Urgent Field Safety Notice

SBN-CPS-2017-003

cobas® 8100 BRF and URF with Software Version 02-xx: Buffering May Cause Specimen Spillage

Product Name	cobas® 8100 automated workflow series
Product Description	BRF for cobas® 8100 URF for cobas® 8100
GMMI / Part No	BRF for cobas 8100 GMMI 07439954001
Device Identifier	URF for cobas 8100 GMMI 07441657001
Production Identifier (Lot No./Serial No.)	Not applicable
SW Version	Software version 02-xx
Type of Action	Field Safety Corrective Action (FSCA)

(Fig 1: English version of screen)

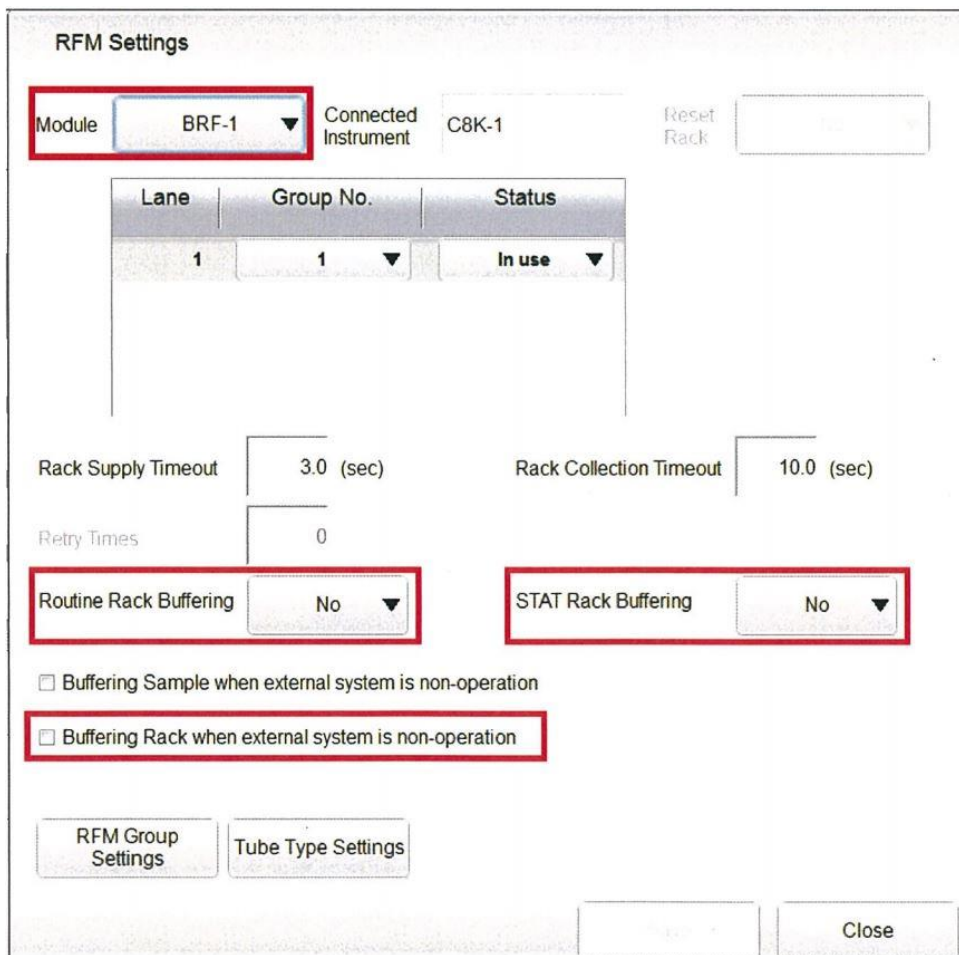
To prevent this issue, rack buffering has to be deactivated until the software is upgraded to version 03-01 onwards. Please refer to the following procedure to disable rack buffering:

- Open the RFM Setting Screen.
- Choose BRF and URF from the pull-down menu for "Module".
- Set "Routine Rack Buffering" to "No".
- Set "STAT Rack Buffering" to "No".
- Uncheck "Buffering Rack when external system is in non-operation".
- Press "Save" button.
- Repeat steps 2 to 6 for all connected BRF and URF modules.
- Reboot the system.

The rack buffering for all BRF and URF modules is required to be disabled in the configuration of the Control Unit, until software version 03-01 is installed. Once version 03-01 is installed the rack buffering for all BRF and URF modules can be re-activated.
